# L Street Station Redevelopment

Supplemental Information Document

Re: **L Street Station Redevelopment Project**  
Boston, MA

776 SUMMER STREET DEVELOPMENT  
East First Street Improvement:

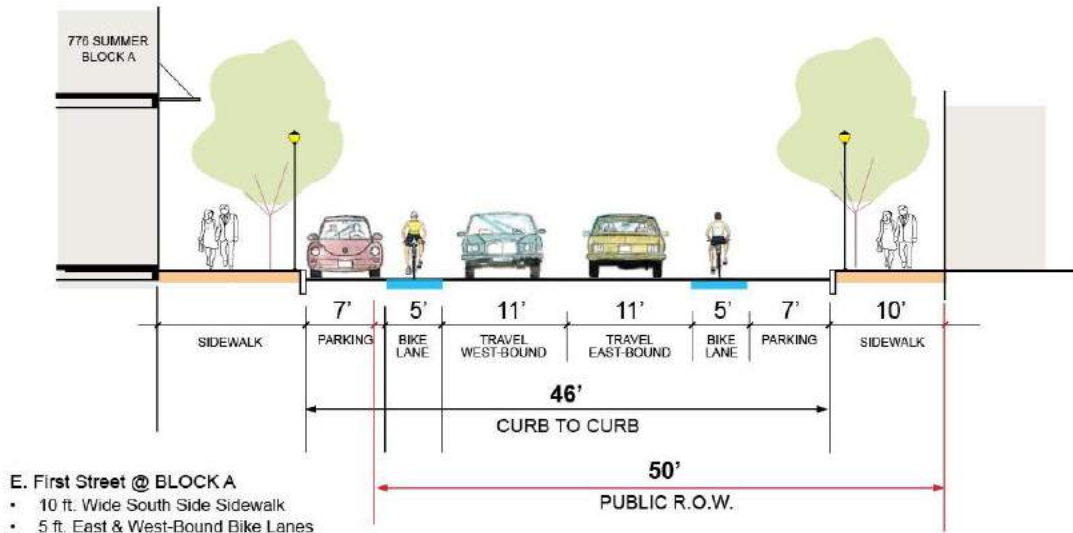
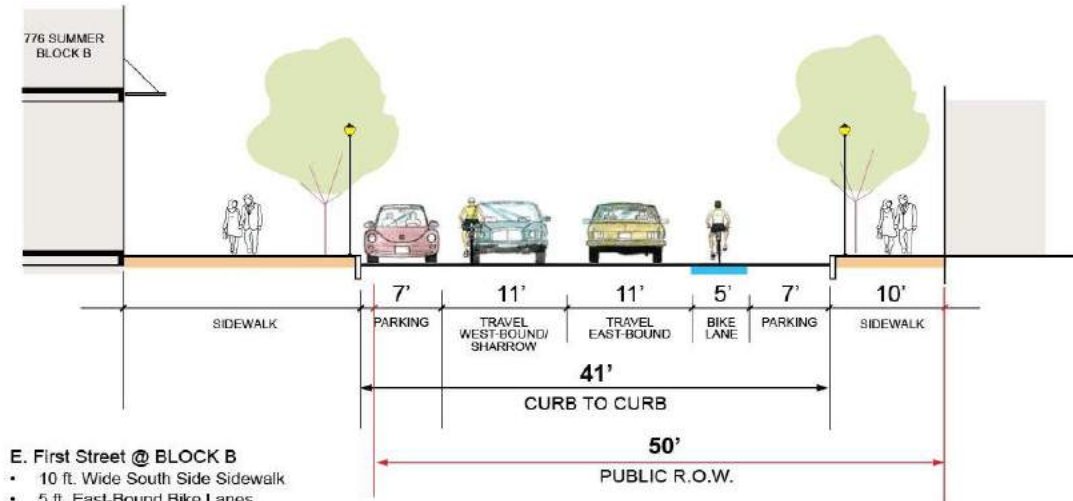
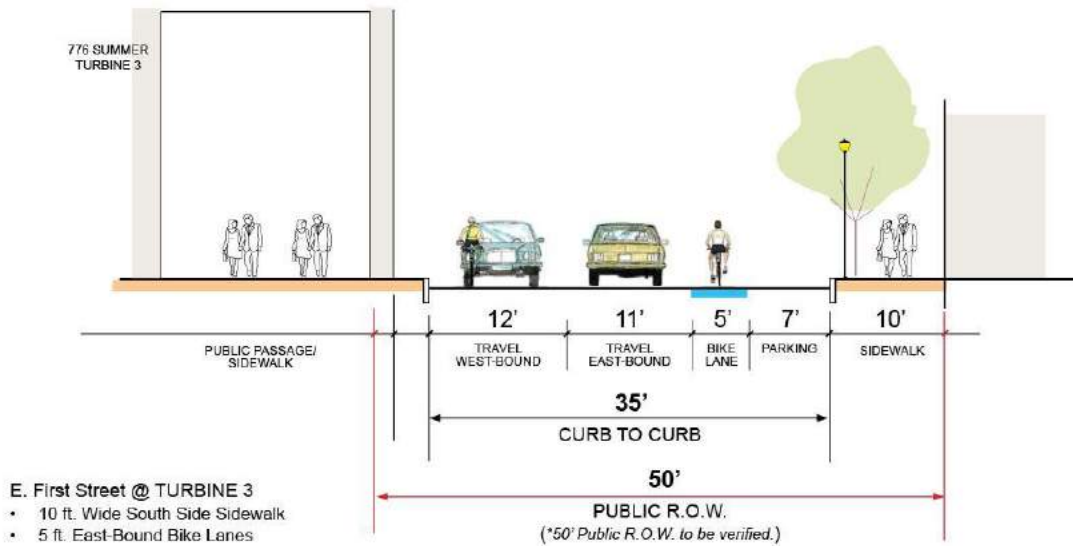
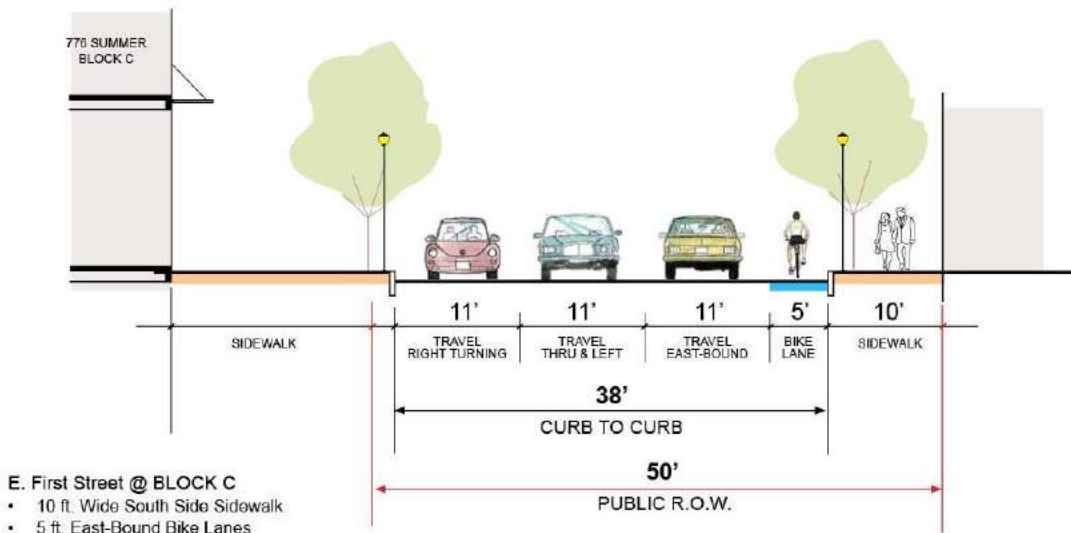
- The Proponent should work with City staff to refine designs for East First Street. This includes recommendations for East First Street cross sections and layout proposed by City staff that would enhance bike and pedestrian accommodations. The following four diagrams from BPDA and BTM staff illustrate layouts for East First Street that provide accommodations for bikes, travel lanes, and parking along with generous sidewalk space. This layout significantly enhances safety for cyclists on the street.
